**RE: Response to Comments**  
**Crawford Station Former MGP Site – SSWP, Addendum 3, Revision 0, Group IV Parcels**  
The Peoples Gas Light and Coke Company  
**CERCLA Docket No. V-W-08-C-917**  
**CERCLIS ID – ILN000510192**

**RE:** Response to USEPA Comments  
Site-Specific Work Plan, Addendum 3, Revision 0, Group IV Parcels  
Crawford Station Former MGP Site, Chicago, Illinois  
The Peoples Gas Light and Coke Company

FIGURE NO. 6A

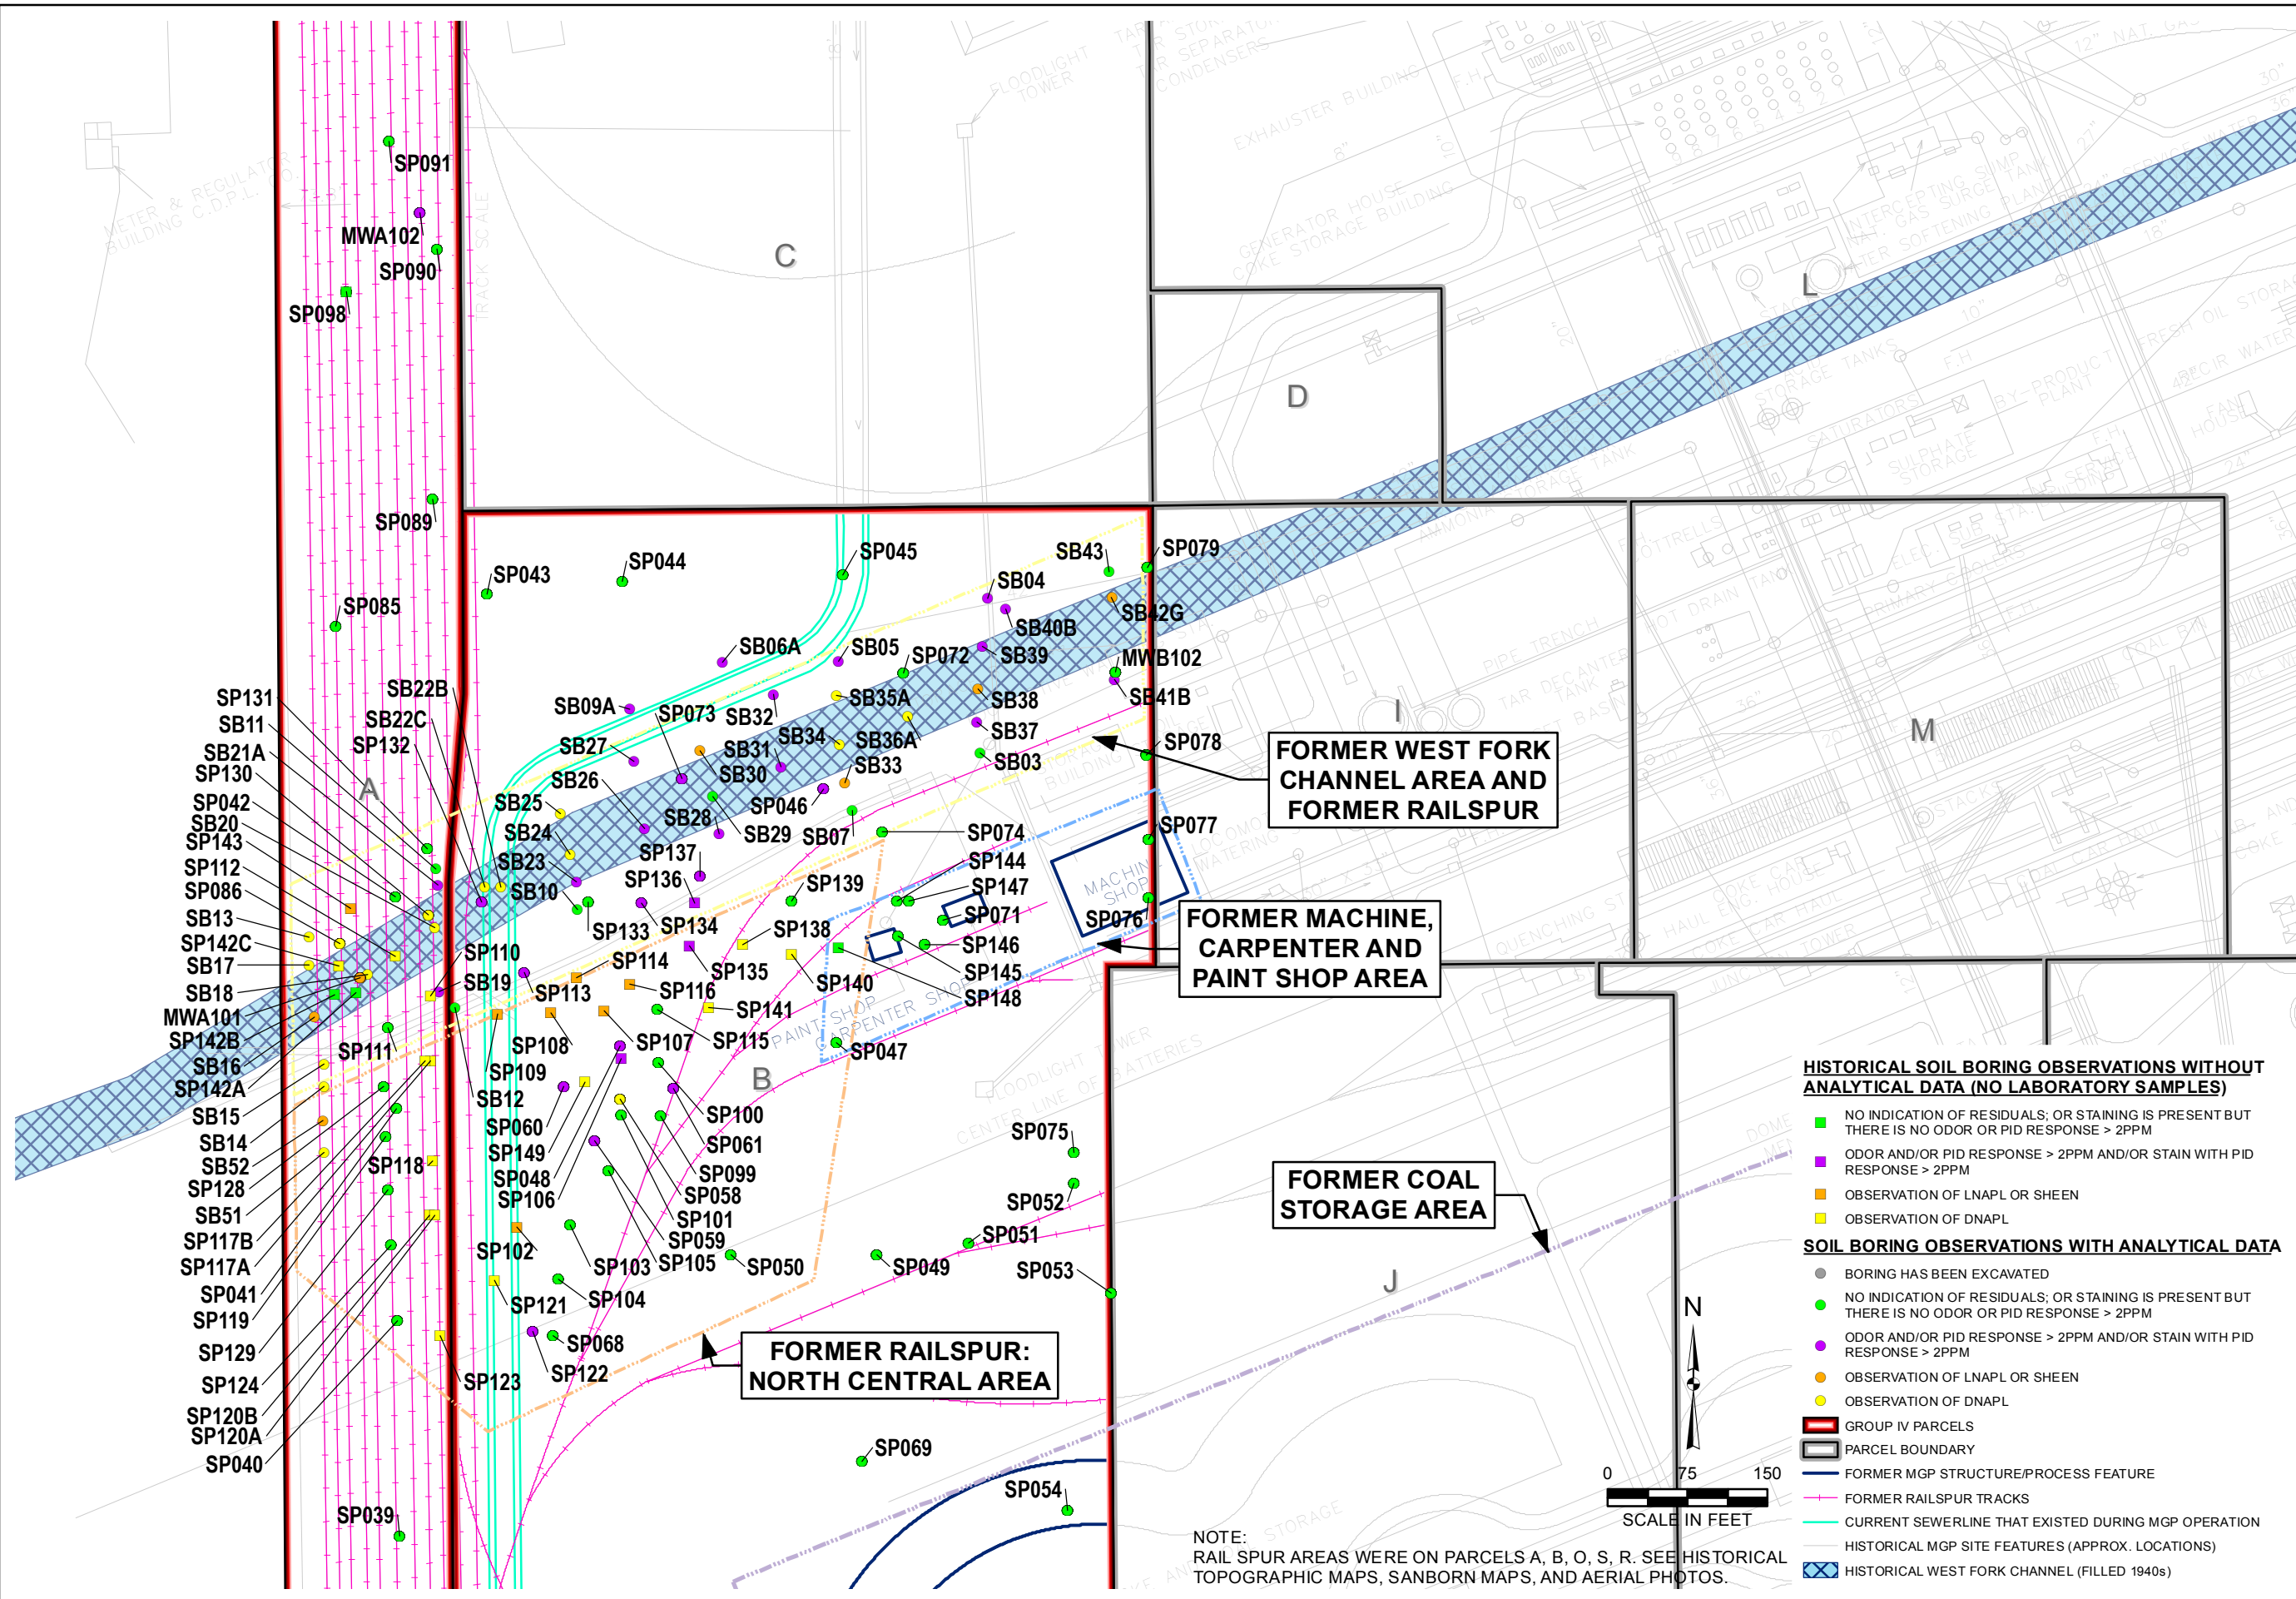
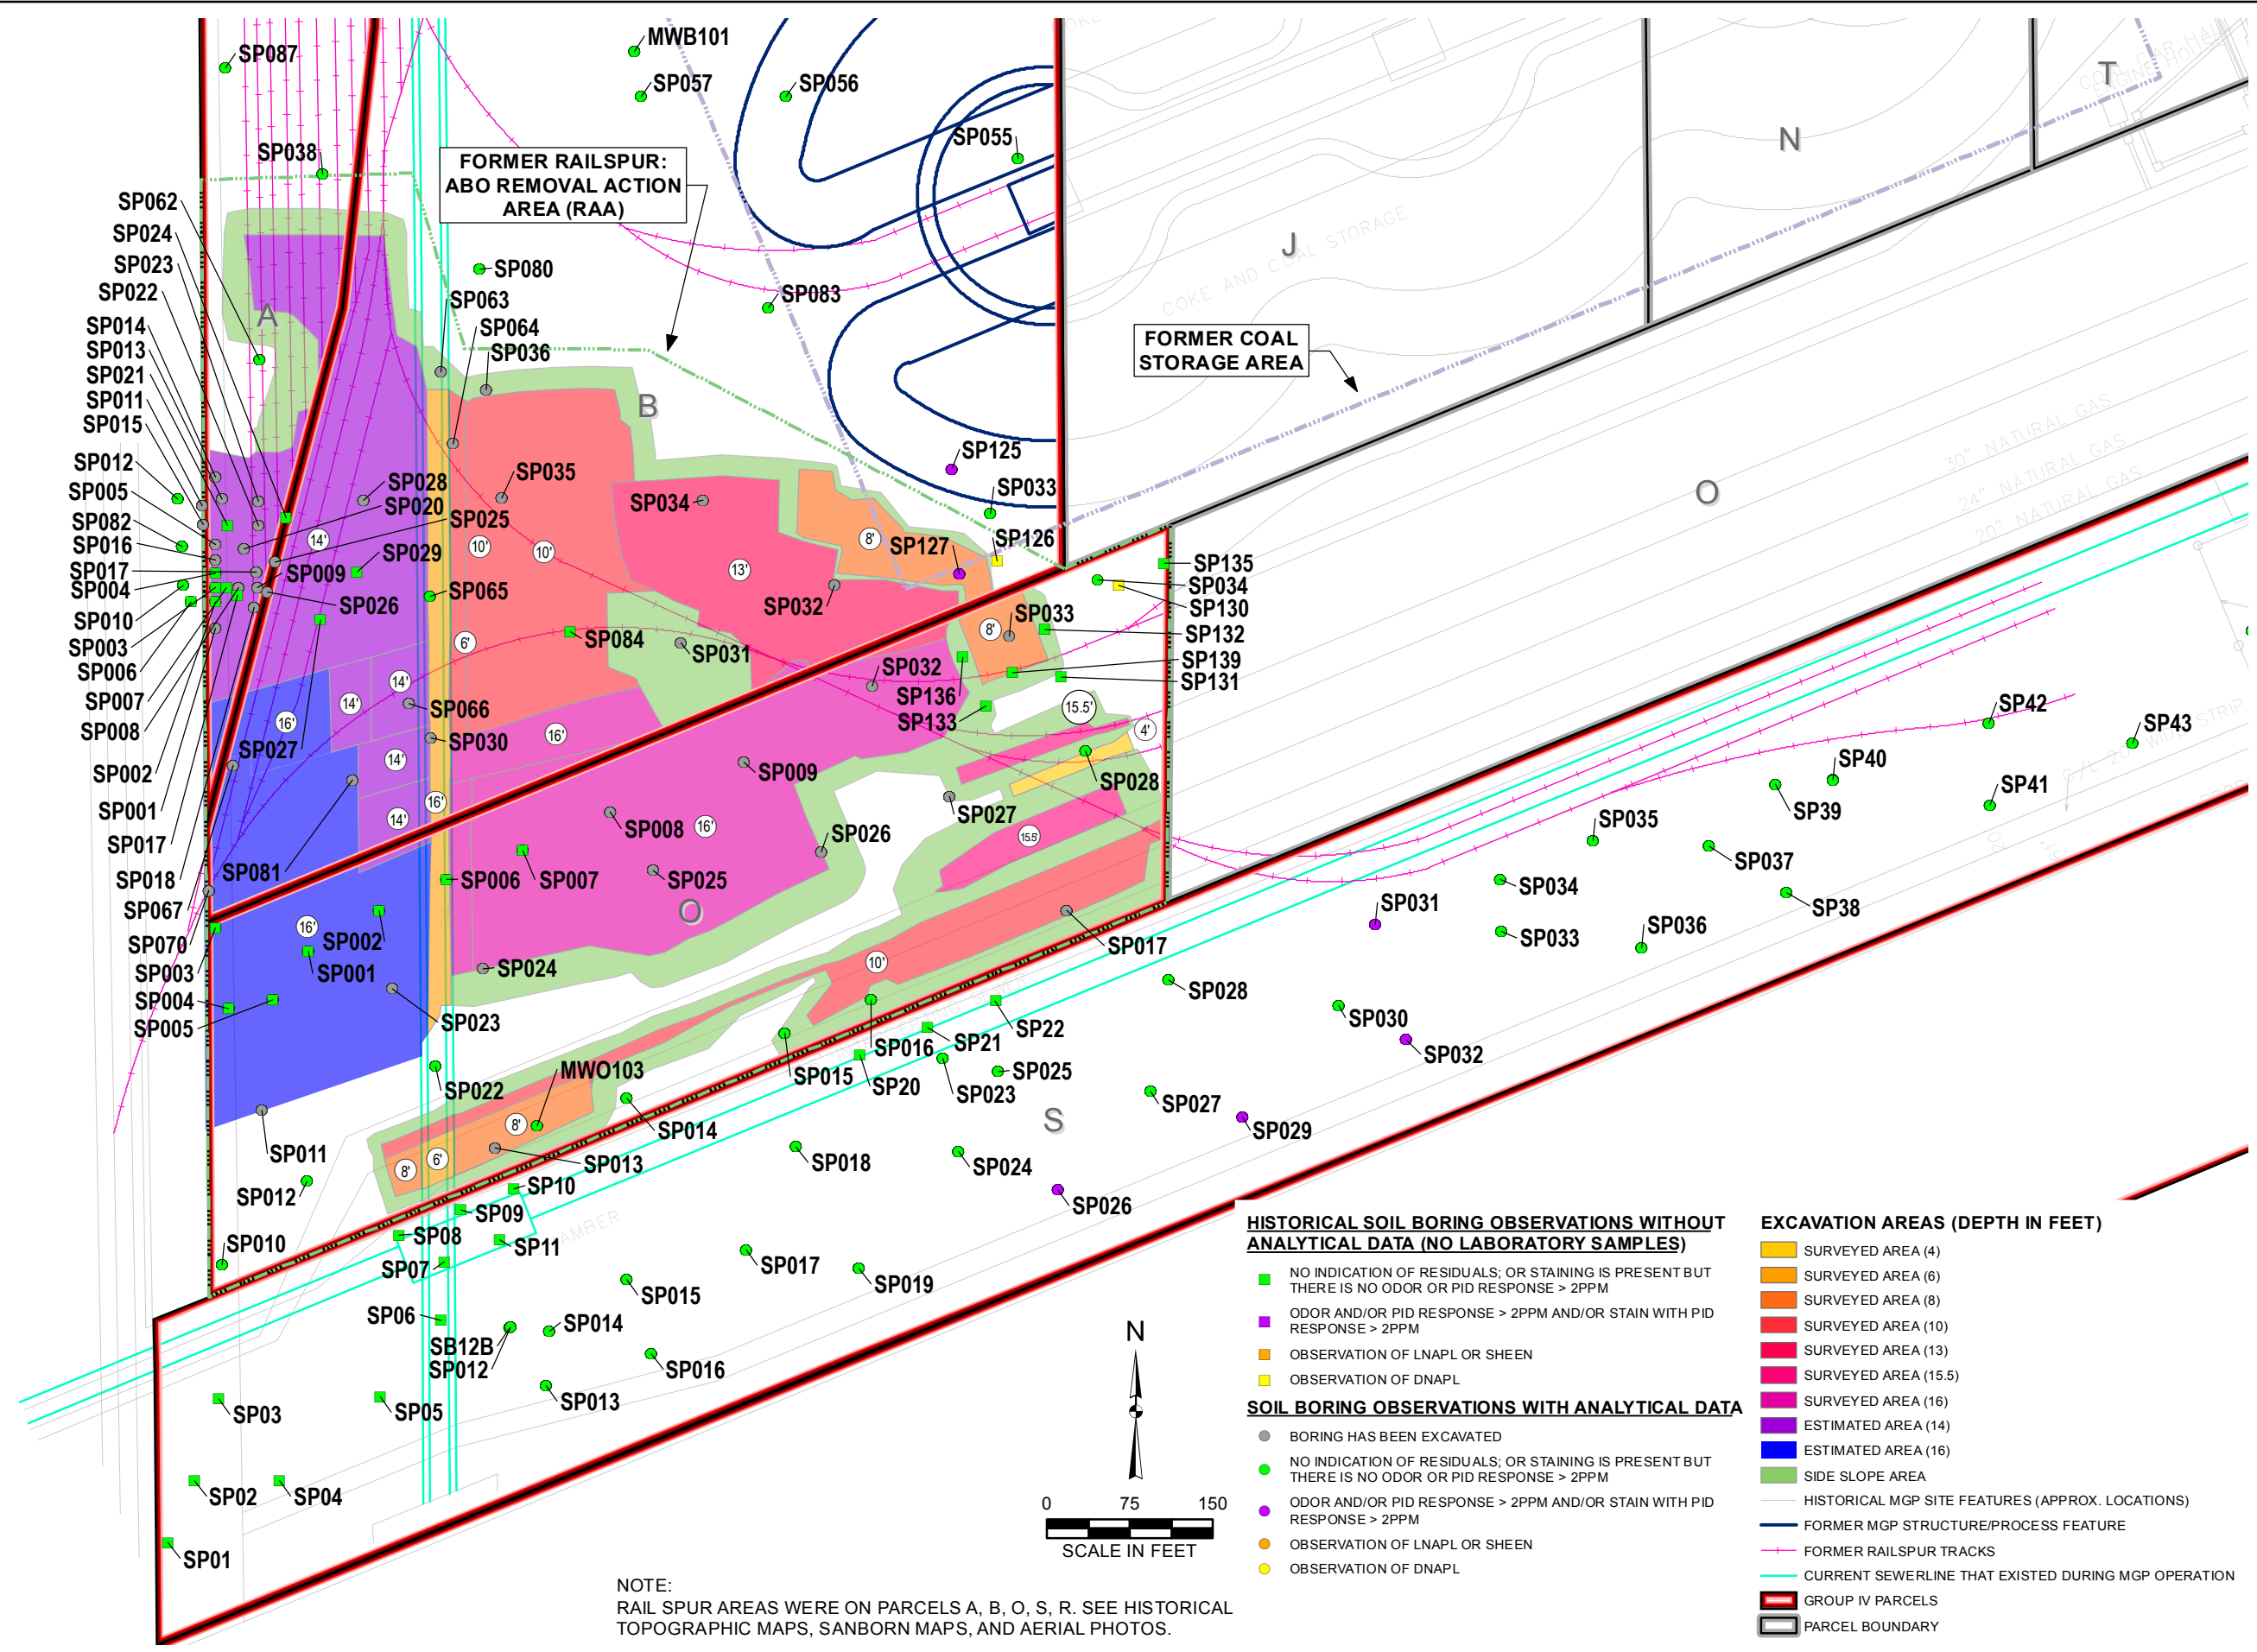
- 1.a. *Section 3.2.1.1 is entitled Rail Spur Area, but this Rail Spur area is not shown/designated on any map. The inclusion of all of the Parcel S data in this Section is confusing because there does not appear to be a rail spur on Parcel S, and it is not obvious where a spur was located in the past. Please clarify the text and figures so it is clear what areas are described in the sections of 3.2.*

**Response to SC 1b:** Section 3.2.1 is organized into two sections (former Rail Spur Areas in Section 3.2.1.1 and former Coal Storage Area in Section 3.2.1.2) for reasons described above. For additional specificity, Section 3.2.1.1 is further divided into four areas where former MGP residuals have been observed. Those four areas are Parcel S and three major areas of Parcels A, B, O (the ABO RAA, the Former West Fork Channel Area, and the North Central Area). These four areas are shown on Figures 6A-6D.

A fifth area, the Former Machine, Carpenter, and Paint Shop Area has been added to figures 6A and 6B. These features, though previously discussed through the text of the other areas, are now combine as one area. As discussed in Section 3.2.1.1, MGP residuals have not been observed in the borings near these features. These features and boring observations around these features are presented on Figure 6B and text has been added to Section 3.2.1.1 to highlight the lack of observations of residuals at these features.
